**NOTICE OF A REGULAR MEETING
BONDURANT PLANNING AND ZONING COMMISSION
AUGUST 8, 2024**

TITLE: Resolution PZ-240808-23 - Considering approval of the site plan for Parcel 2024-102.

TITLE: Resolution PZ-240808-24 - Considering approval of the site plan for Featherstone Apartments.

BONDURANT STORAGE
2020 2ND STREET NE, BONDURANT, IOWA
DIMENSION PLAN

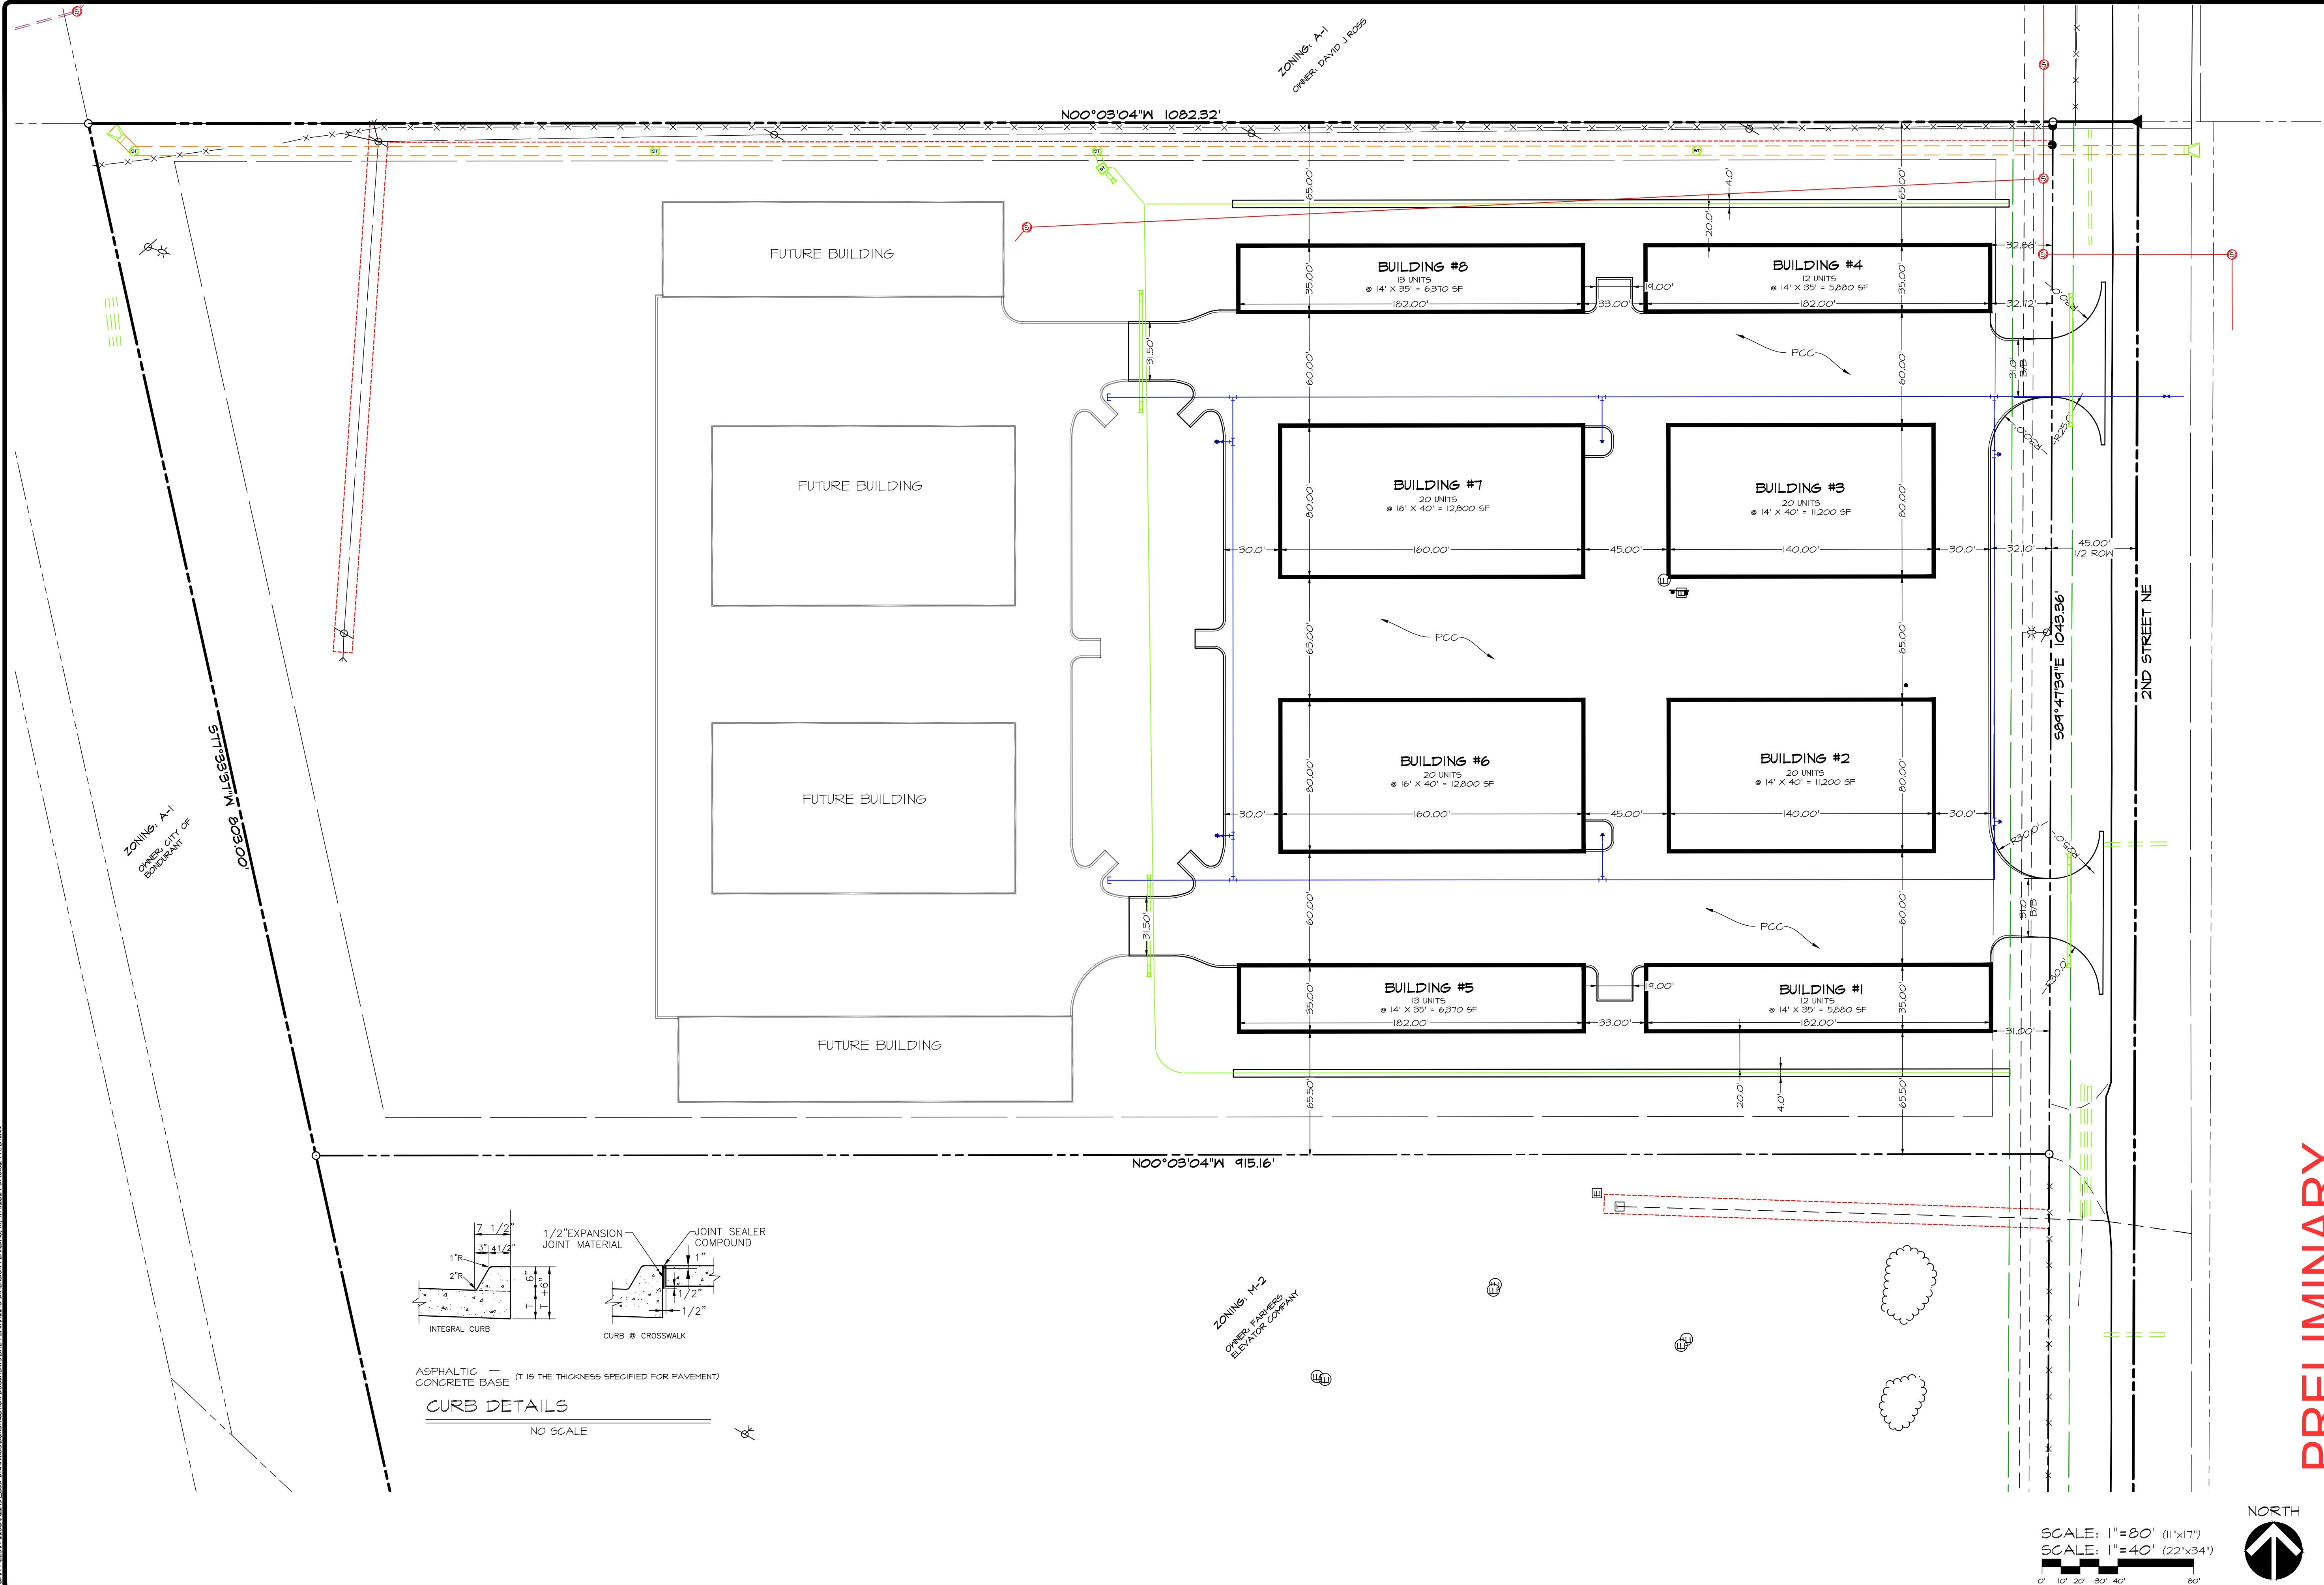
- The site plan labels the required setbacks at this location - a 30' front yard setback along 2nd Street NE, a 40' rear yard setback along the northern property line and 20' side yard setbacks along the eastern and western property lines.
- The site plan currently shows no outdoor storage areas.

- Access to the site is proposed from 2nd Street NE.
- The site plan shows 8 storage unit buildings of varying sizes. The largest storage building will be 12,800 square feet and the smallest will be 5,880 square feet.

- The site plan shows the parking/drive/loading area as being at least 10' from right-of-way lines.
- The site plan shows all parking/drive/loading areas as 6" P.C.C. which meets code requirements.
- The site plan does not show any parking spaces on site. Parking will be provided directly in front of individual storage units.
